**SUNDRY NOTICES AND REPORTS ON WELLS**

ConocoPhillips Company

SJ 32-8 Unit #259A

BOP Configuration

## BLOWOUT PREVENTER ARRANGEMENT & PROGRAM

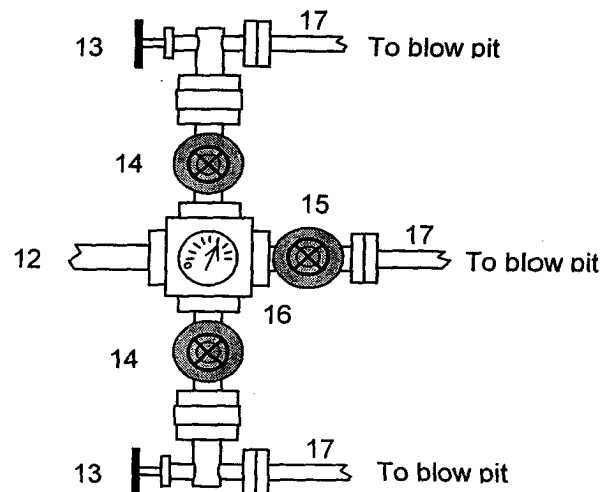
Due to problems with the planned BOP Key Energy was using, ConocoPhillips needs to change the BOP configuration initially submitted to the following:

To request an exception to Onshore Order #2 to

- Allow us to test our BOP and 9-5/8" surface casing to 1000 psi in lieu of Onshore Order #2 requirements

See attached BOP Schematics - one for drilling to total depth & setting 5-1/2" producing casing.

This BOP arrangement is for the drilling operations from the time the 9-5/8" surface casing is set through the setting of the 5.5" production casing. The Casing Head "A" Section will be screwed onto the 9-5/8" surface casing stub. The BOP will be installed on the Casing Head "A" Section. The pipe rams, blind rams, choke manifold, and 9-5/8" surface casing will be tested to a low pressure test of 200 psi to 300 psi and to a high pressure test of 1000 psi (this value is one 44% of the minimum internal yield pressure of the 9-5/8" casing). A 7-7/8" hole will be drilled to total depth, and 5-1/2" casing will be run and cemented.
